Application of Wisconsin Public Service Corporation for Authority to Construct and Place in Operation a New Multi-Pollutant Control Technology System for Unit 3 of the Weston Generating Station, Marathon County, Wisconsin

Docket No. 6690-CE-197

**Rebuttal Testimony of Jeremy Fisher, Ph.D. On Behalf of Clean Wisconsin**

**December 14, 2012**

**Figure 2. Energy efficiency potential at WPS relative to Weston 3 generation for 1.6% and 1.9% annual incremental energy efficiency.**

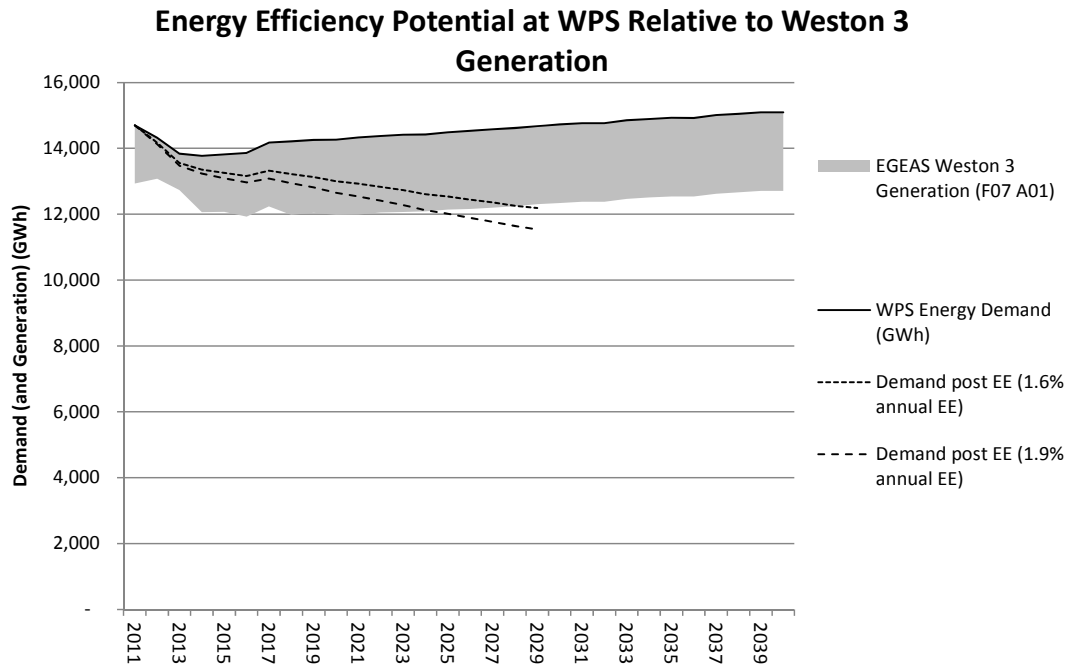
5 **A** Yes. I went back to the Company’s EGEAS output to review both annual  
6 expected output of the Weston 3 unit (putting aside concerns about Weston 3’s  
7 expected output that I raised in my direct testimony)<sup>30</sup> and total Company demand  
8 as portrayed in the model. Using output from Future 7, Scenario 1 (the  
9 Company’s revised base case scenario with Weston 3 intact), I estimated the  
10 annual estimated growth rate, the annual incremental savings rate (at 1.6%), and  
11 the impact of savings that Ms. Stemrich estimated were already in the baseline  
12 (84,000 MWh).<sup>31</sup>

13 I assumed that, because of the savings already in the baseline, additional annual  
14 incremental savings amounted to only 1.03%,<sup>32</sup> and applied this value year-by-  
15 year through 2016, inclusive.

16 With these fairly conservative assumptions in place, I found that by the end of  
17 2016, WPS could have secured over 36% of their generation requirement for  
18 Weston 3 through efficiency (see **Figure 2**, below).
